1966 Corvette: Engineering Service Letter: RPO K-66 Wiring Diagram for Breakerless Ignition System

Subject: RPO K-66 Wiring Diagram for Breakerless Ignition System
Model and Year: 1966 Chevrolet, Chevelle, Chevy II, and Corvette with RPO K66
Source: Chevrolet Engineering Service Bulletin
Bulletin No: TSB #11
Section: NA
Date: November 11, 1965

1966 CHEVROLET, CHEVY II & CHEVELLE

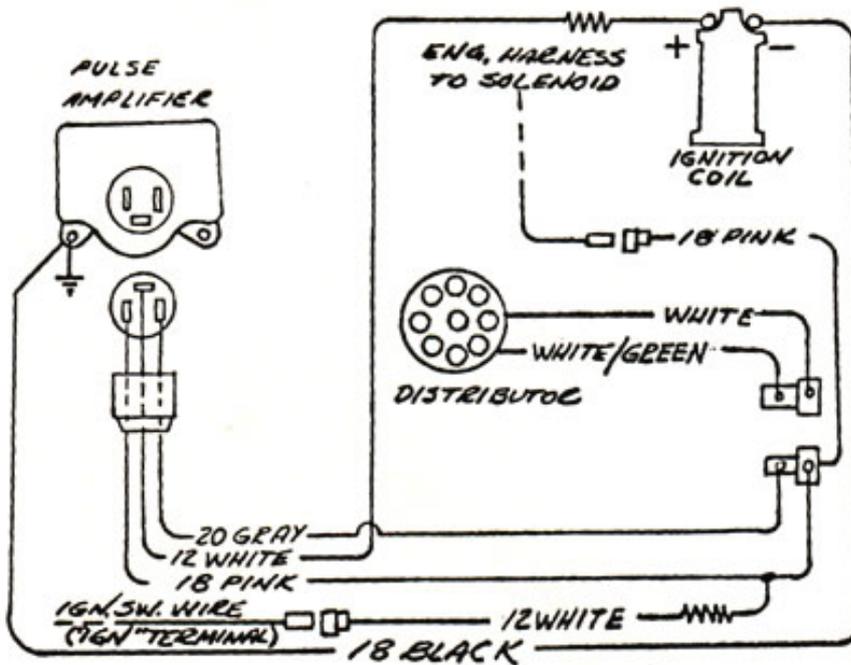
With reference to the 1966 Passenger Car Chassis Service Manual, Section 6Y-15, the wiring diagram of Figure 3.i requires clarification. The diagram on the left side of Figure 3.i should be titled "Chevrolet, Chevy II, and Chevelle" and the right side diagram should be titled "Corvette" (see attached.)

On the Corvette diagram, the "12 white" wire and the "20 black" wire from the negative ignition coil terminal to ground on the pulse amplifier should be an "18 black" wire for its entire length. The "12 white" is a calibrated resistance wire and is located on the negative side of the ignition coil on 1965

vehicles. However, in 1966 this resistance was placed on the positive side of the coil for added protection of the pulse amplifier in the event of accidentally grounding the ignition coil wire. This change has been incorporated in the passenger car models only.

The pulse amplifier in the left side view of the figure should reflect that the unit is grounded.
